**EVALUATION OF HALTON REGION
LANDFILL TECHNICAL STUDIES
Site F - Burlington**

DESIGN AND OPERATIONS REPORT

CRA
Consulting Engineers

March 1, 1988

figure B2.1

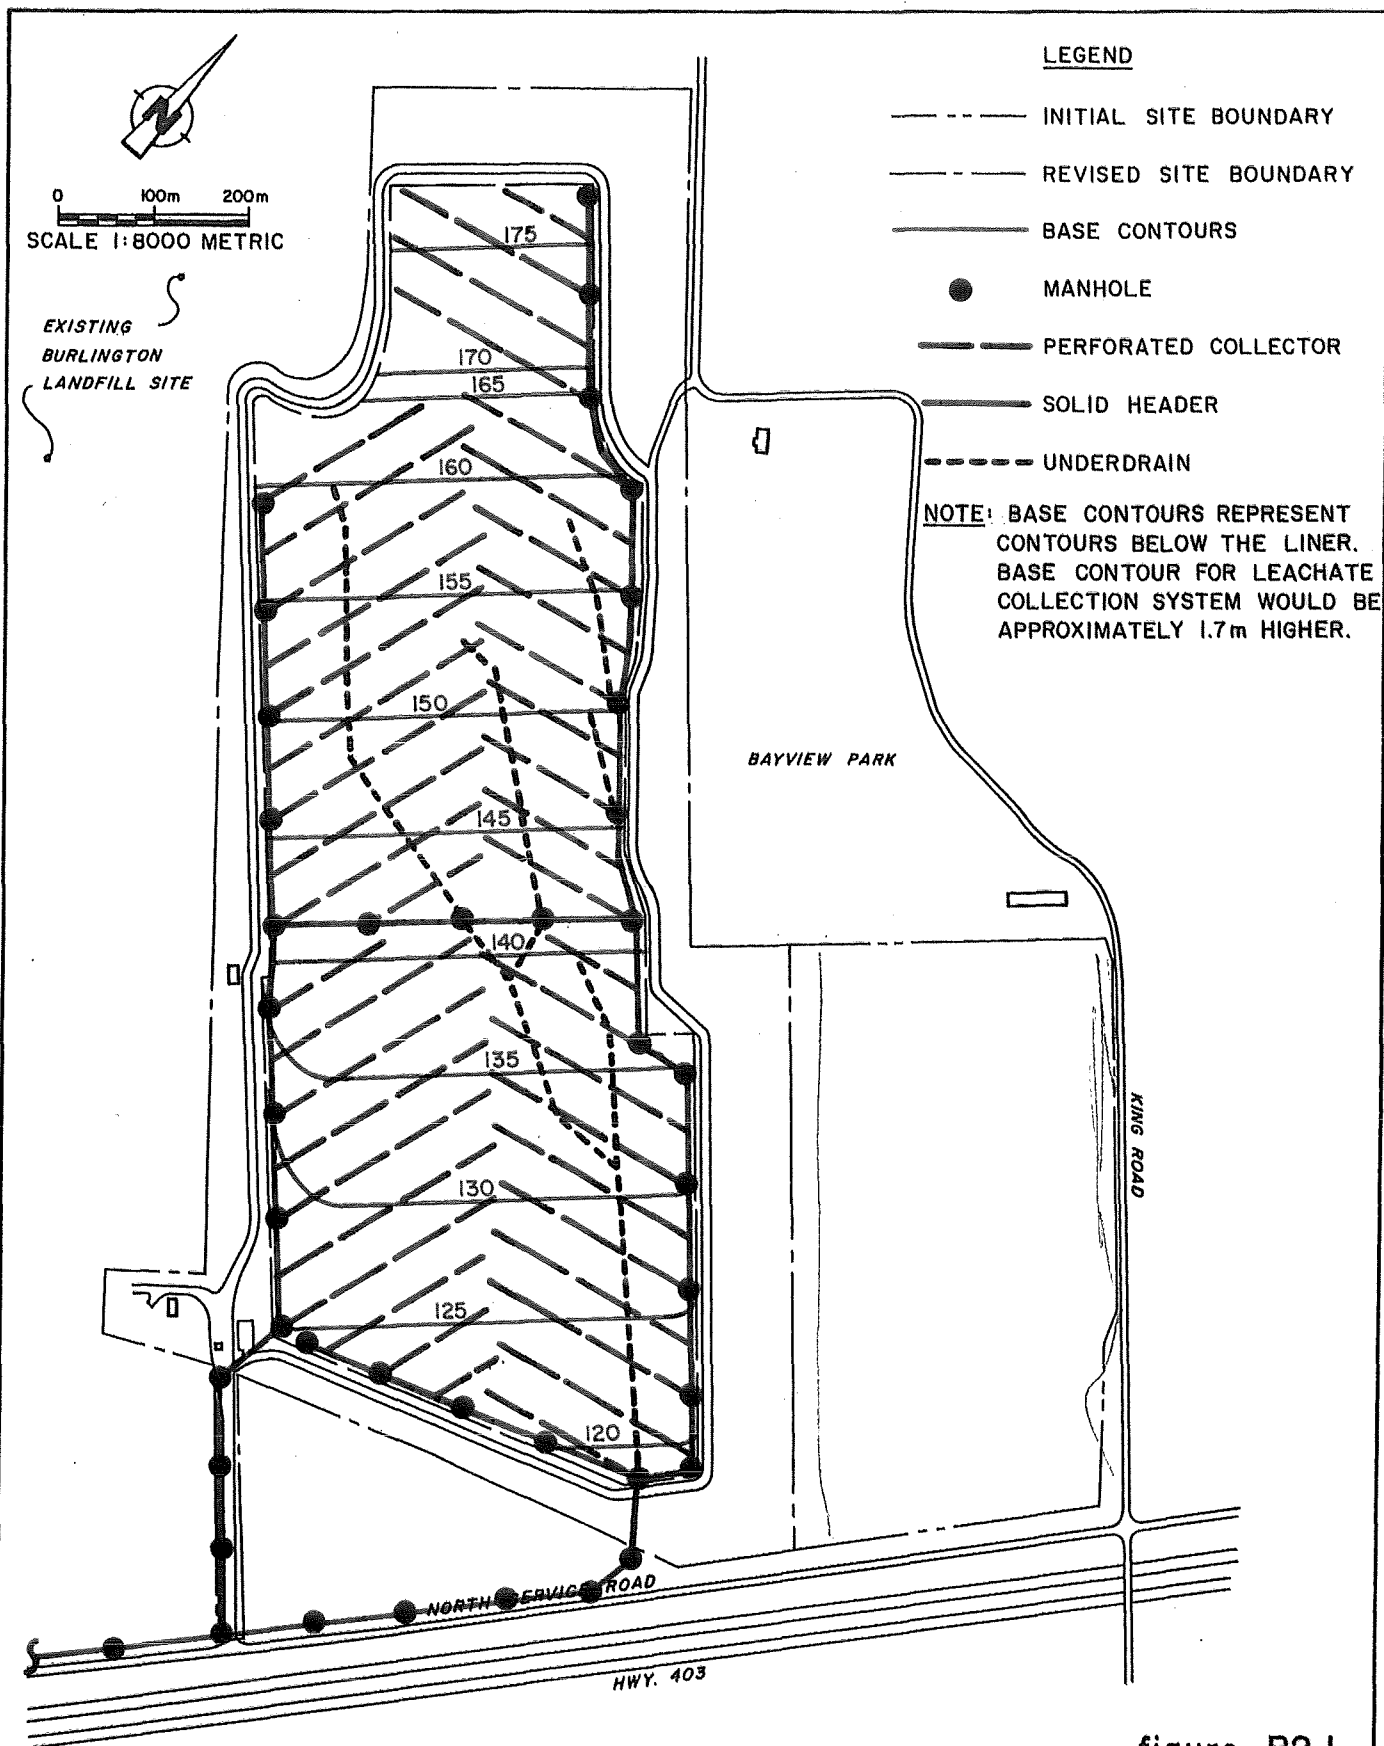
Based on the leachate collection system design criteria and the design illustrated in Figure B.2.1 (page 34), the following were noted:

Because of these considerations, it is recommended that the liner design for Site F be modified in order to adhere to the design criteria presented in Part A.

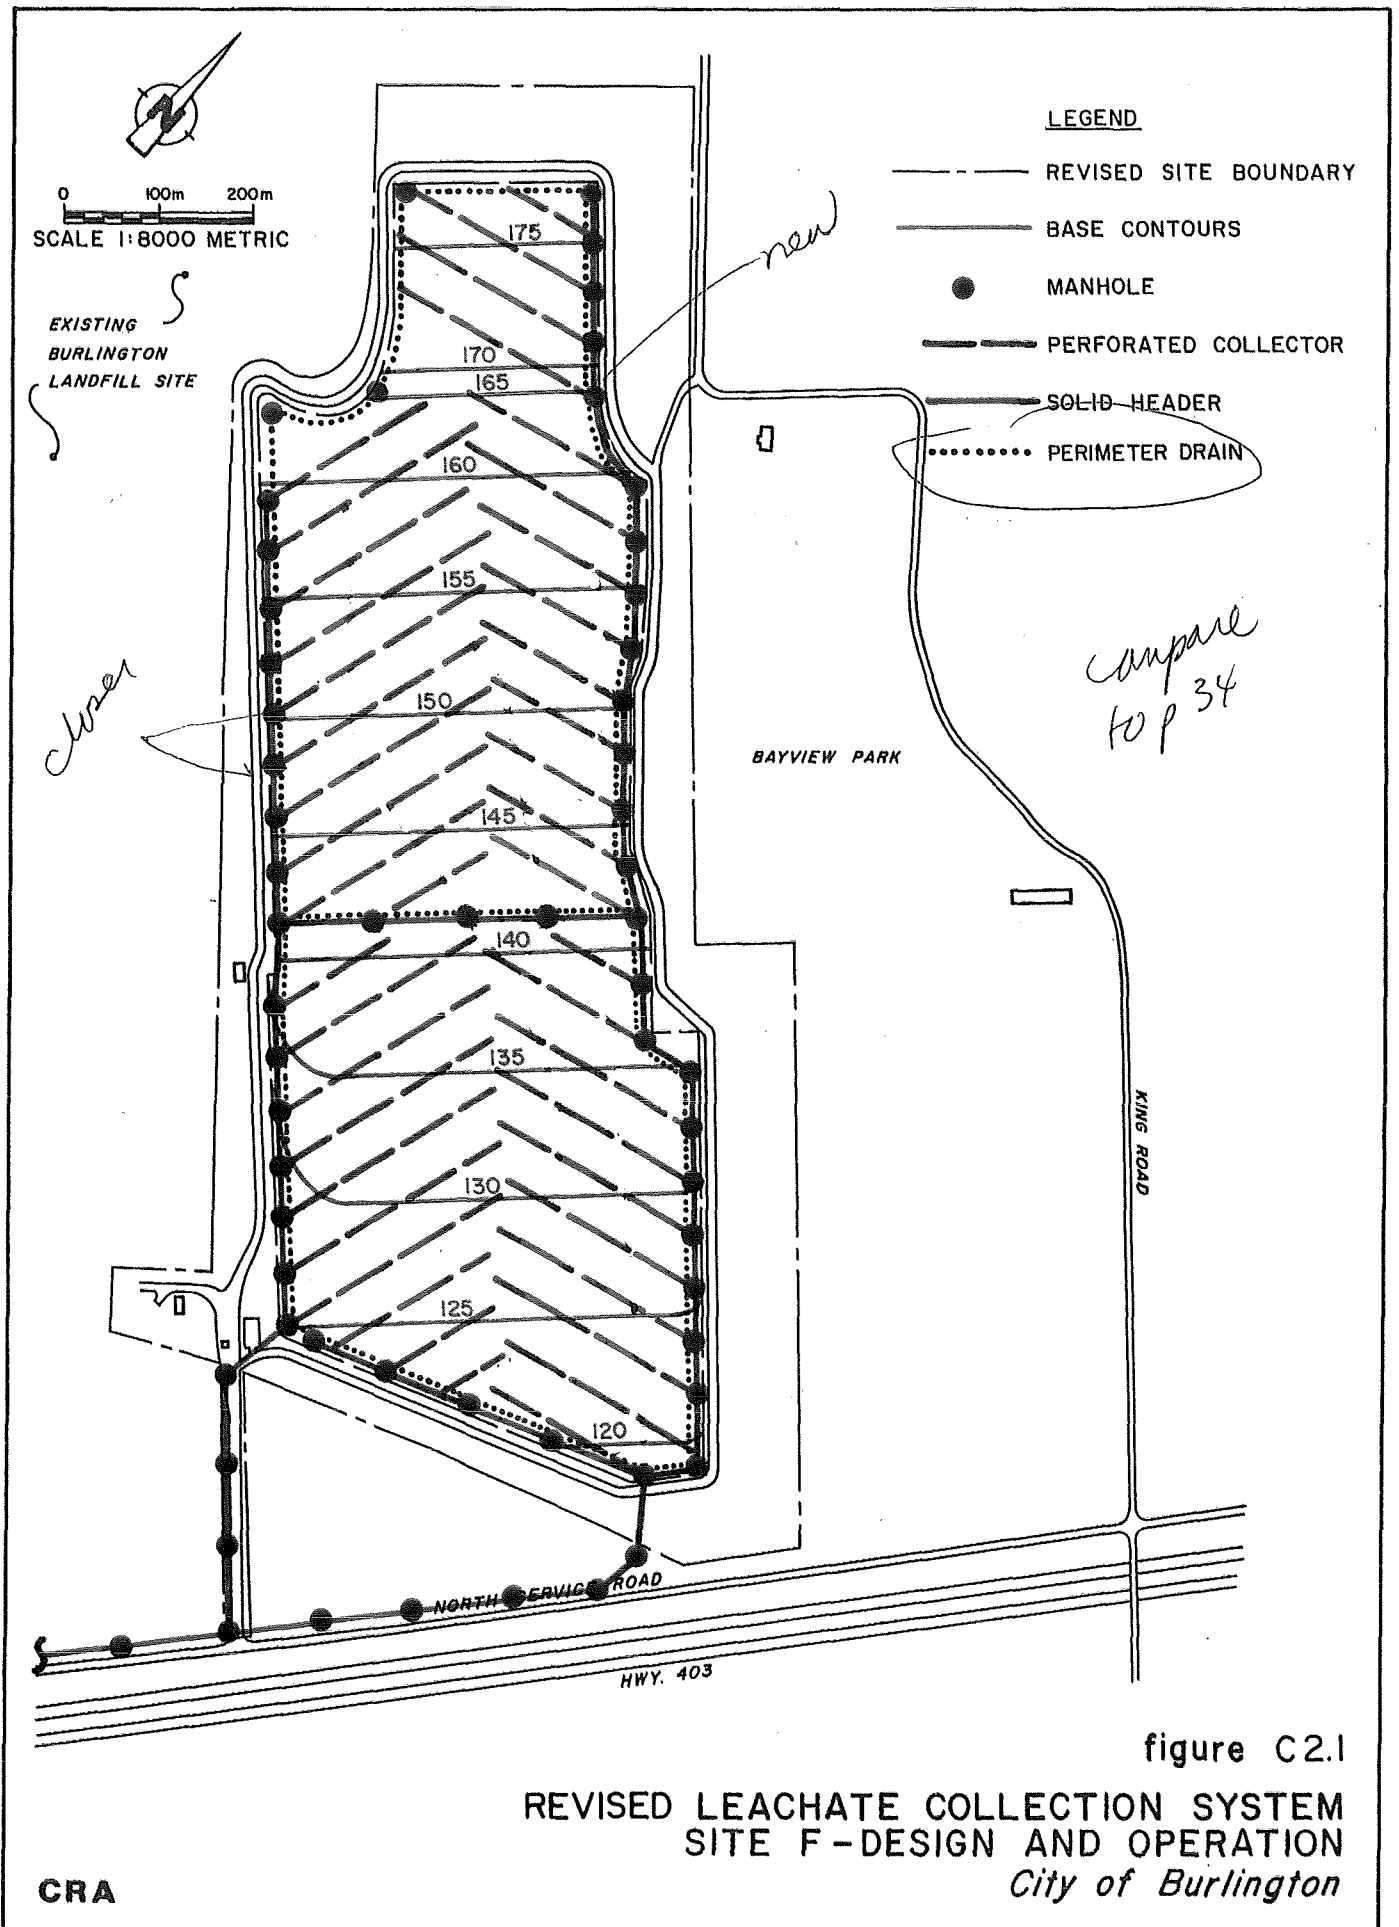
1. Enhance the accessibility of the perforated collectors for cleaning and maintenance.
2. Provide a perforated perimeter drain.

Figure C.2.1 (page 55) provides a conceptual layout of proposed revisions to the leachate collection system. Details are not included, but unless otherwise noted would be as provided by Trow. Features of this system include:

1. Parallel header lines extending the full length of the landfill along the eastern and western limits of fill.
2. To facilitate maintenance of the perforated collectors, place manholes at the end of each perforated collection pipe.
3. Perforated collectors placed in a granular bed on top of the clay liner, and extending from the mid-point of the site to the collection headers located along the eastern and western limits of the landfill.

4. A perforated drain around the perimeter of the base of the site.
5. A temporary east-west header at the southern limit of Cell No. 1.

Features 2 and 4 represent revisions to the Trow Design. The underdrain system included in the Trow design was removed since the underdrain system of the liner system would serve the same purpose. By providing these design modifications, the leachate collection system will adhere to design criteria provided in Part A of this report.
